# Regulatory Compliance Report

Eastern Creek Quarter Stage 3  
Rooty Hill Road South

Prepared for: **Frasers Property**  
Date: **15/08/2022**  
Revision: **C**

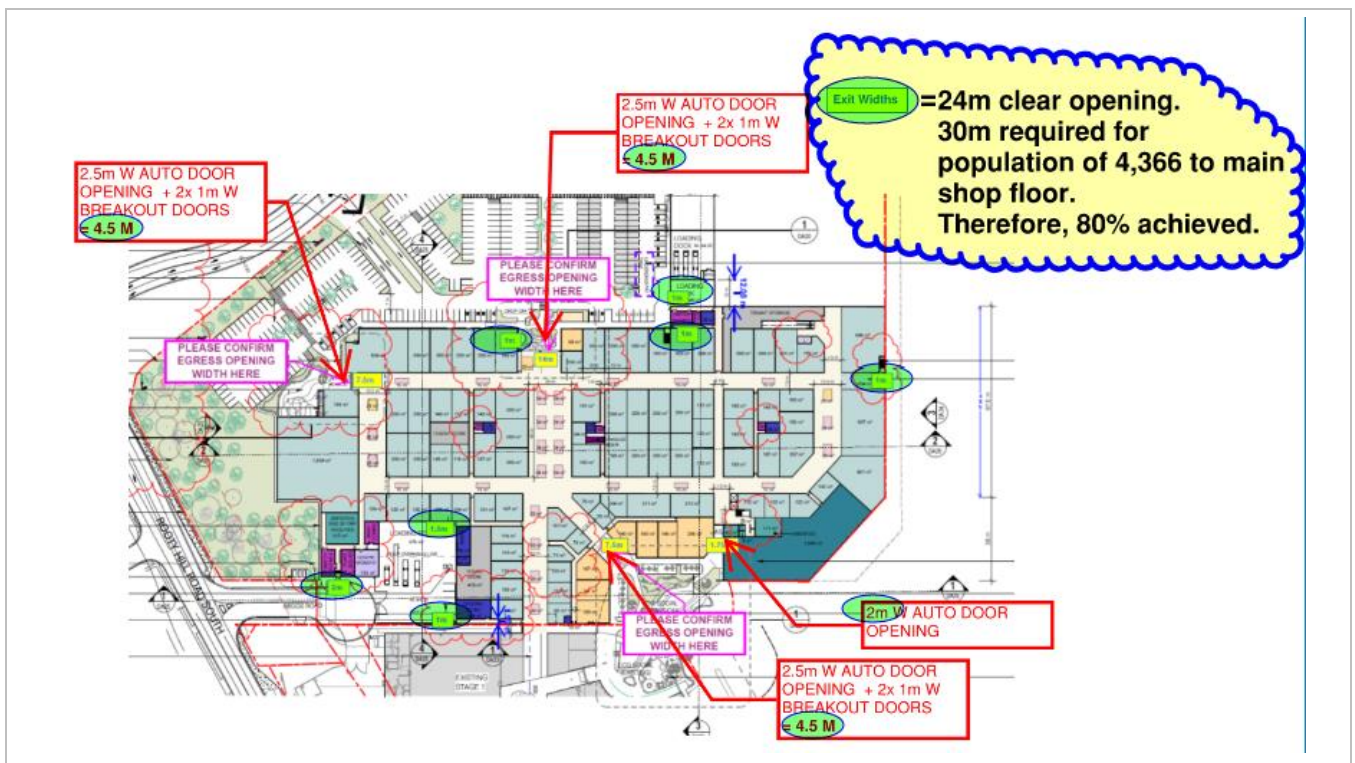
Storey	Number of people	Exit Width Required	Exit Width Provided
<b>Main Retail Floor</b> (minus Food & Beverage, and Tavern)	4,366	<b>30m</b>	*24m

\*The clear opening aggregate exit widths have been determined by the architect as per the mark-up below. It is noted that there is a shortfall of about 6m, which is 80% of the required aggregate width that could be addressed through Performance Solution by an accredited fire engineer.
